Addendum No. 001

Subject: George W. Childs School – Classroom Modifications
SDP Contract Nos. B-071C, B-074C of 2017/18

This Addendum, dated May 9, 2018, shall modify and become part of the Contract Documents for the work of this project. Any items not mentioned herein, or affected by, shall be performed strictly in accordance with the original documents.

DRAWING NO.
E112

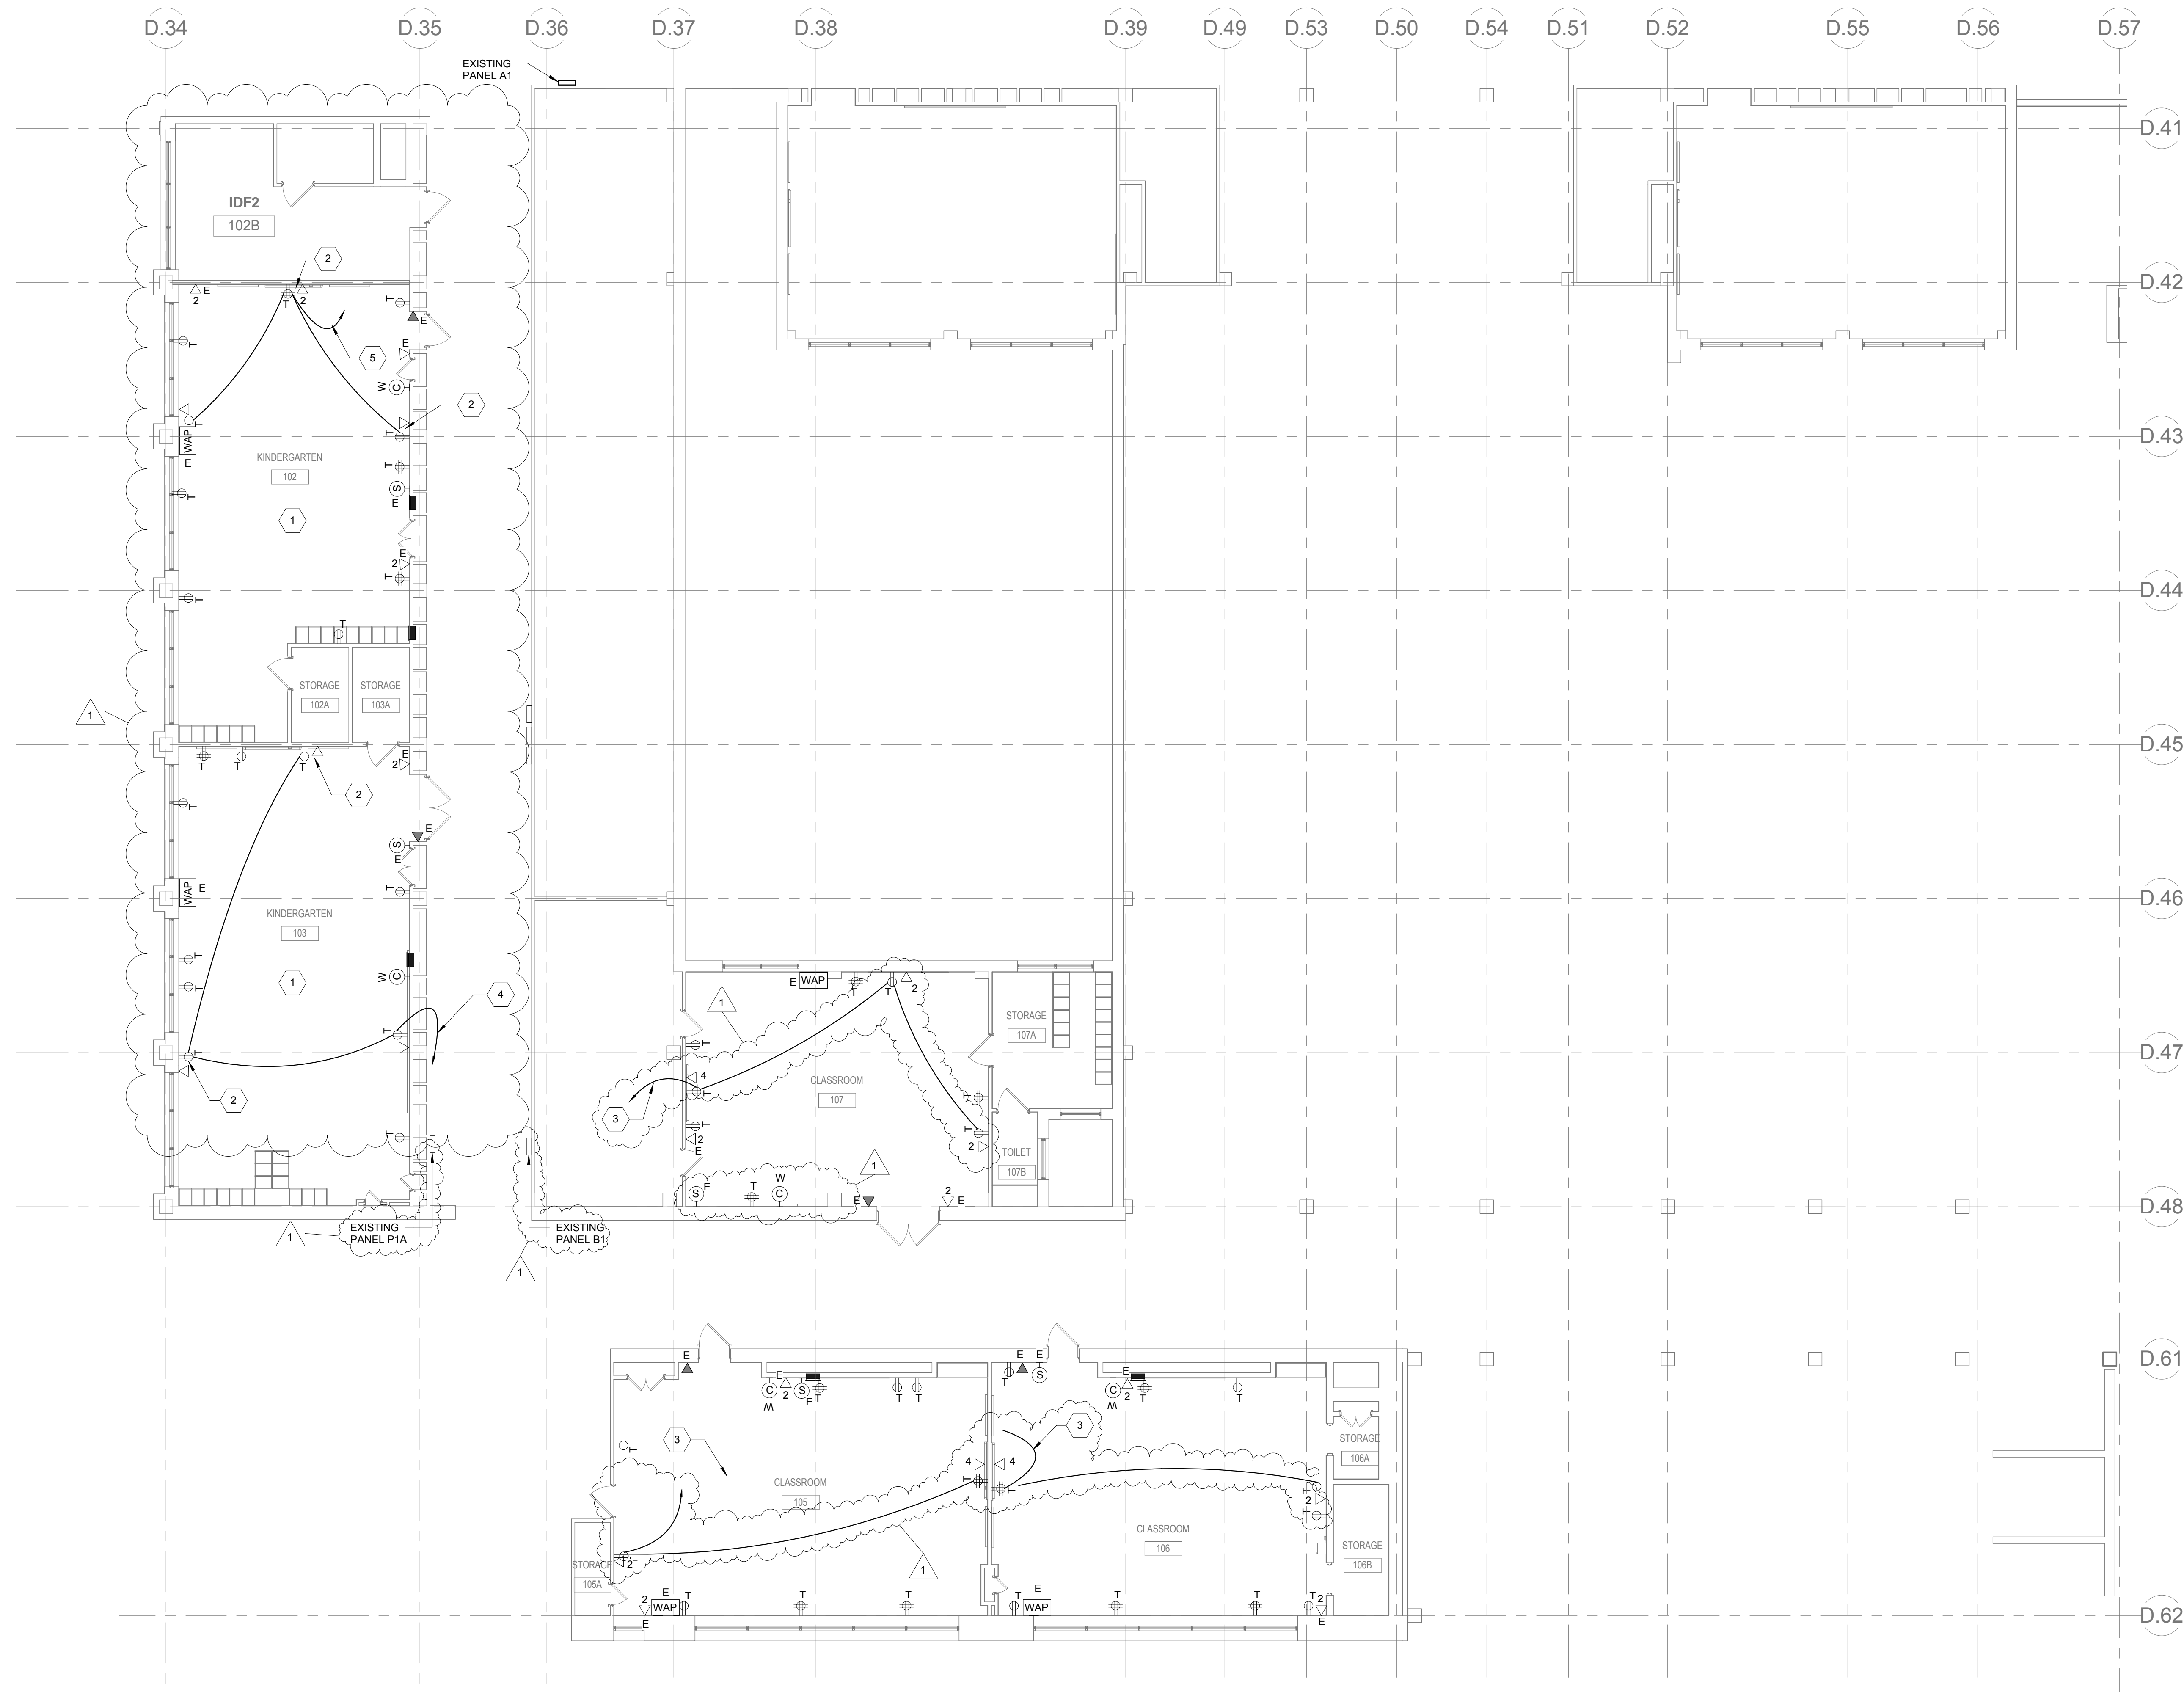
- a. Added receptacles in rooms 102, 103, 105, 106 and 107.
- b. Added IDF room 102B.
- c. Added key notes 1, 2, 3, 4 and 5.
- d. Added key plan, graphic scale and north arrow.

DRAWING NO.
E121

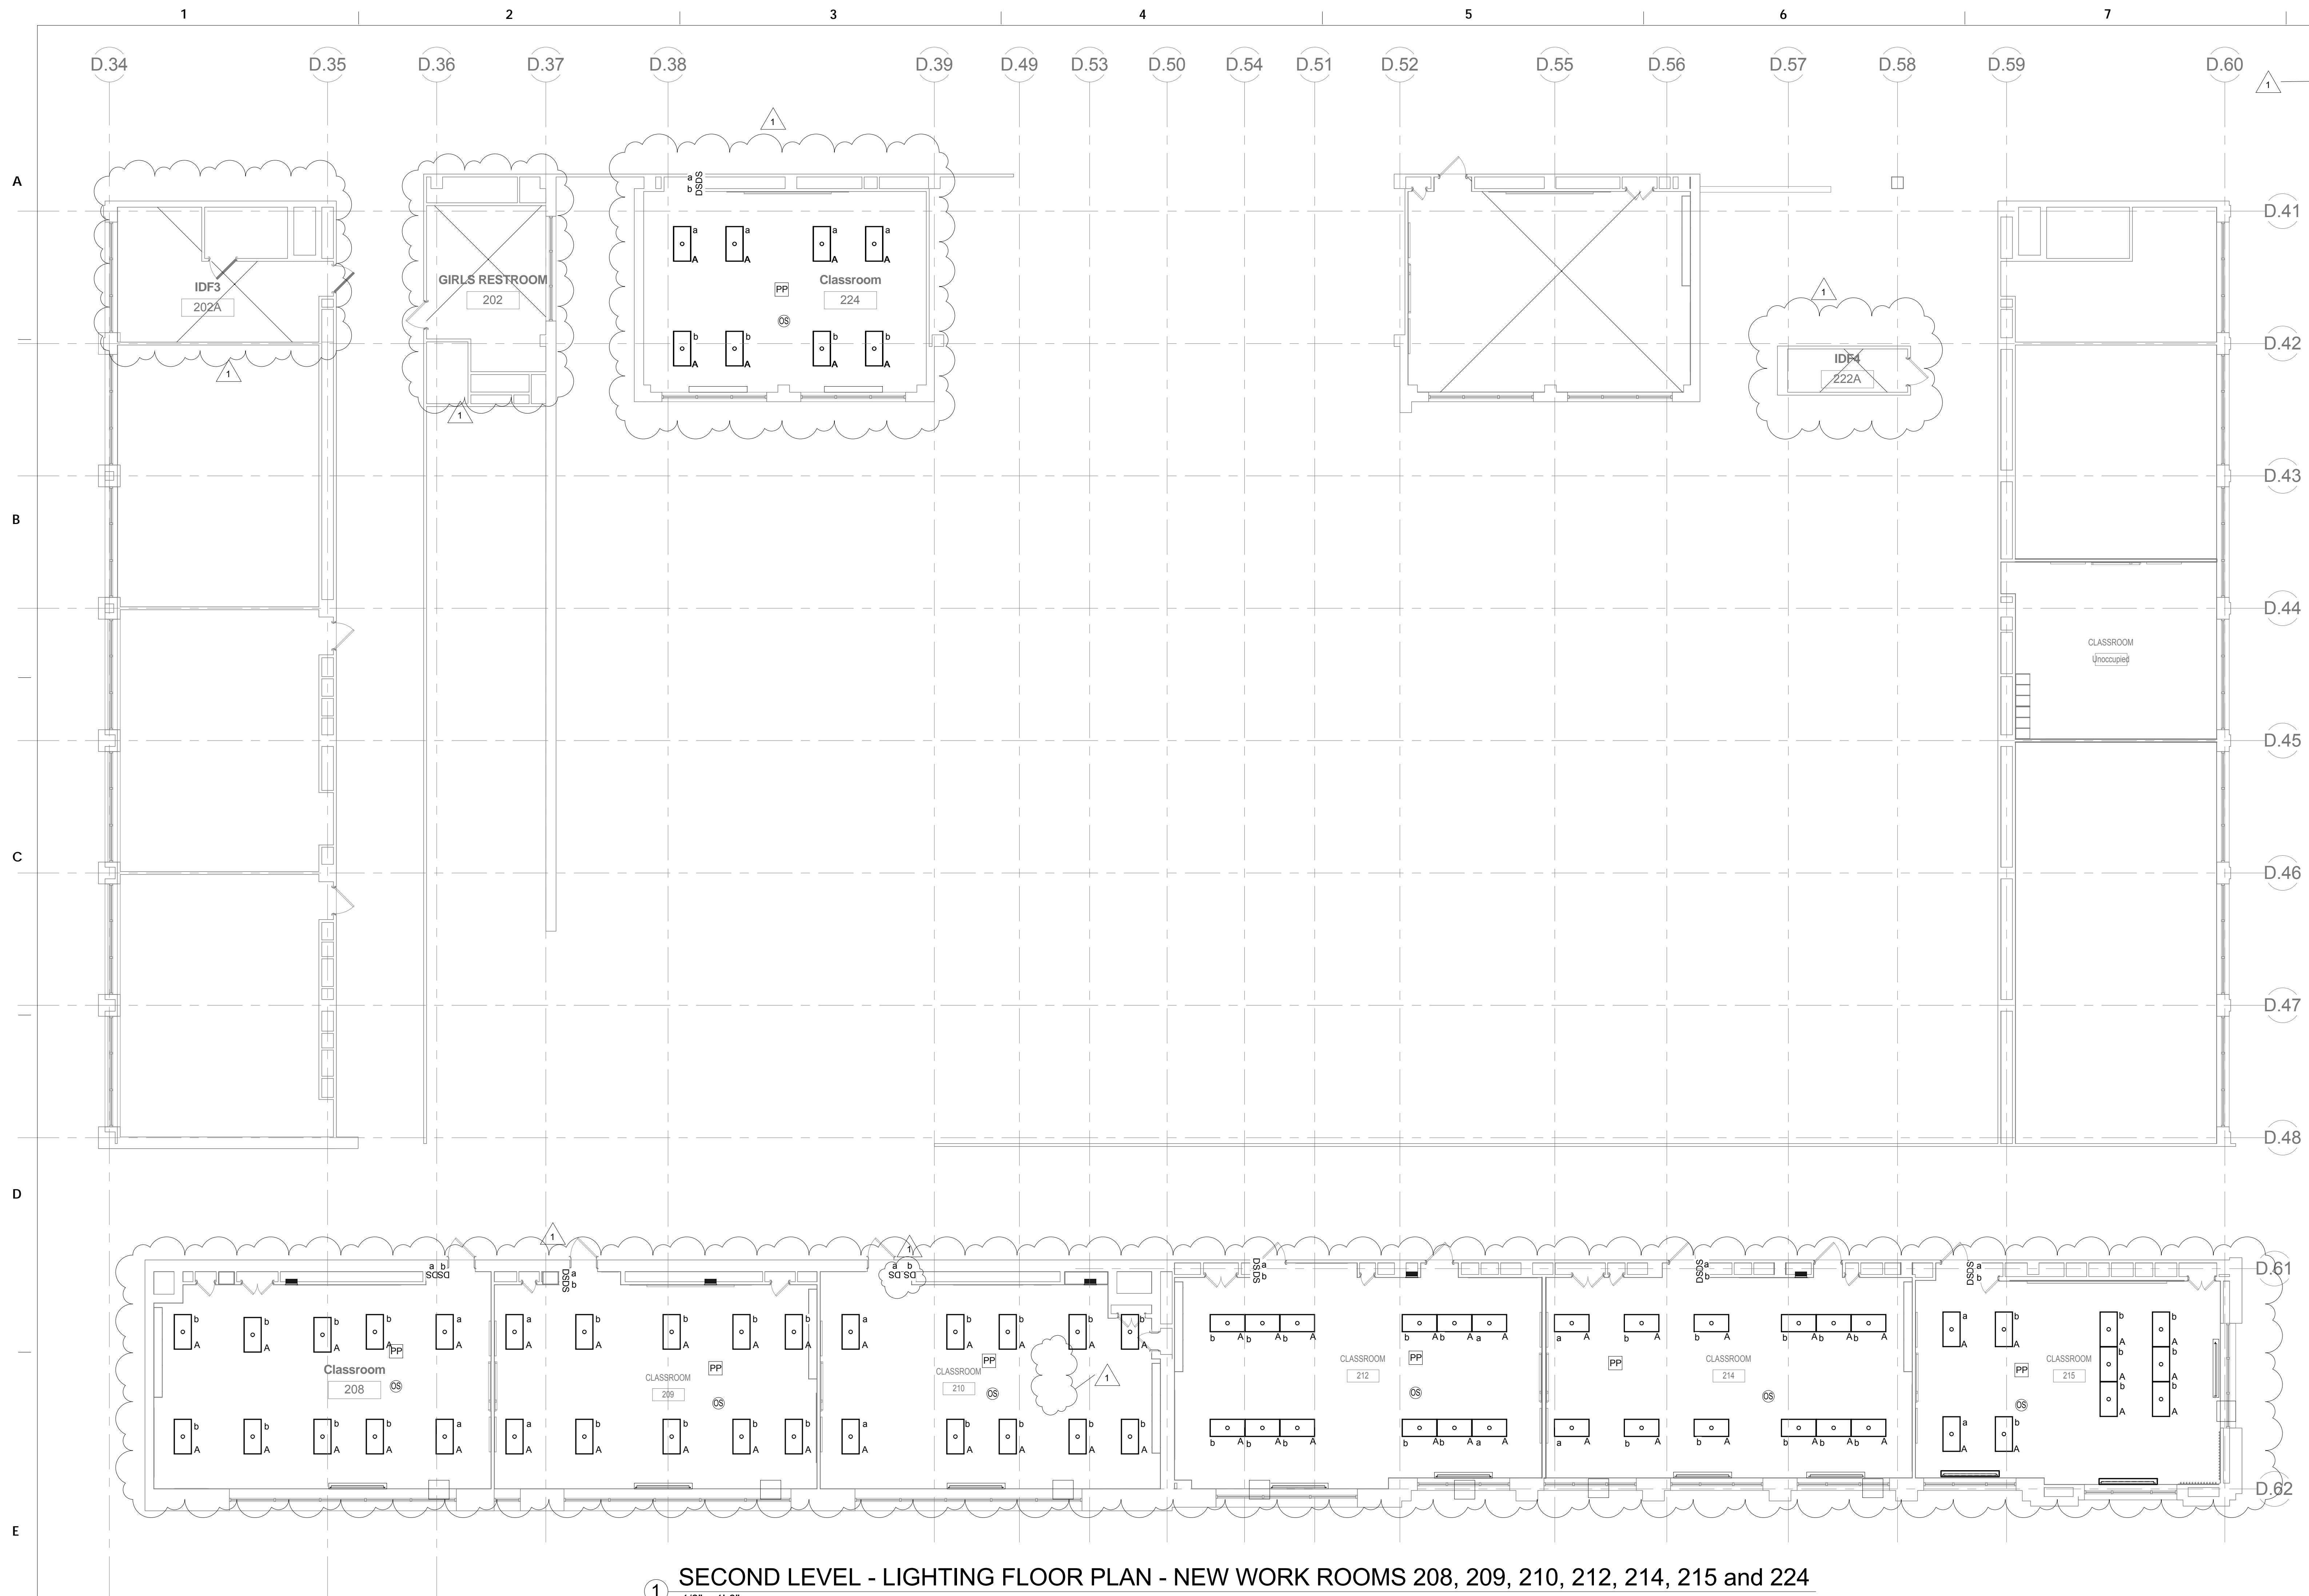
- a. Revised lighting layout and switching in rooms 208, 209, 210, 212, 214, 215 and 224.
- b. Added IDF3 room 202A and girls restroom 202.
- c. Added key plan, graphic scale and north arrow.
